TO: Design Review Commission
FROM: David Kornfield, Planning Services Manager
SUBJECT: 14-SC-43 – 582 Glen Alto Drive

TO: Design Review Commission
FROM: David Kornfield, Planning Services Manager
SUBJECT: 14-SC-43 – 582 Glen Alto Drive

Approve design review application 14-SC-43 subject to the findings and conditions

ELEVATIONS

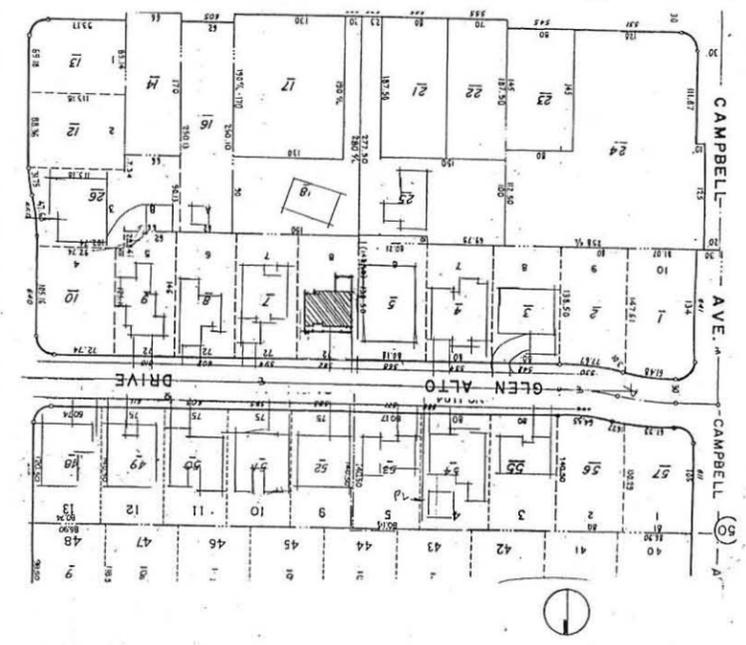
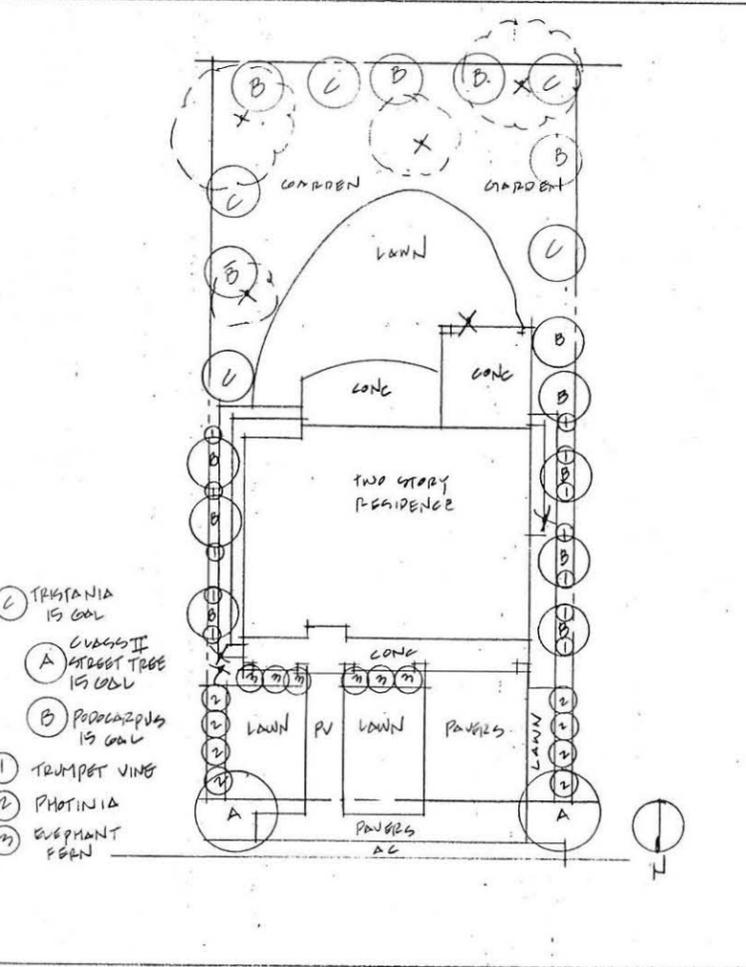
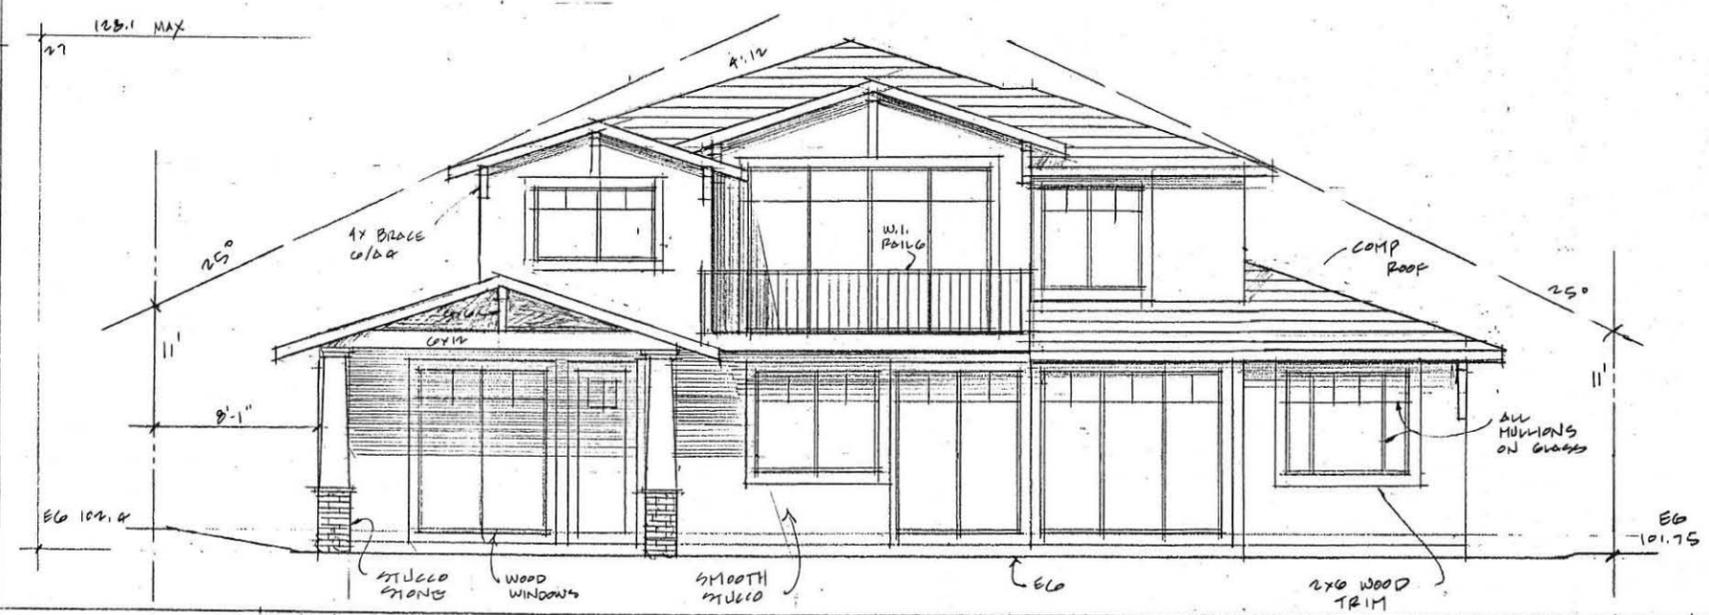
1. The front yard setback was increased by three feet, to 28 feet, to align with the structure with the west;
2. The rear porch was reconfigured from a 20-foot deep, gable roof projection to an eight-foot deep hip roof;
3. The rear-facing balcony was omitted; and
4. The roof pitch was lowered, which resulted in an overall height reduction of two feet, for an overall height of 25 feet.

Four neighbors spoke in opposition and gave the following comments: concerned about the covered patio in the rear yard that has large visual impacts; a flat roof or other design should be used for the covered porch; the roof should be removed or replaced with lower massing or moved to a different location on the lot; concerned about the two-story windows on the side elevation; reduce the number of windows and plant more trees; every other house has a 10-foot side yard setback; and the design is not compatible with the neighborhood. There was no other public comment.

The commissioners discussed the project and provided the following comments: concern about the house maxing the building envelope; concern about the balcony and privacy impacts on a narrow lot; design is too bulky and massive and doesn't fit in the neighborhood; should change height and massing to not tower over the adjacent homes; plans need more detail and work; and the project needs to be continued to address neighbor concerns.

In the process of changes the house moved towards the rear of the lot by three feet. This still has a negative impact on our light and views of the sky and distant tree tops. Moving it forward three feet to where it had been planned would remedy this and would also be better for both our and the new homeowners' privacy.

Another area of concern is the placement of two air conditioners on the side of the lot facing us, where there had not been any on the prior plan. We are very worried about the noise they will generate. Their fans will never run at the same speed and this will create a "sing-song" (e.g., an irritating modulation of sound). We like to open our windows for fresh air, especially during the summer, and would like peace and quiet. We ask that at a minimum the one towards the rear of the house be moved farther away from us.

- Reduce the bulk and mass for better integration with the neighborhood.
- Work to address the neighbors concerns.
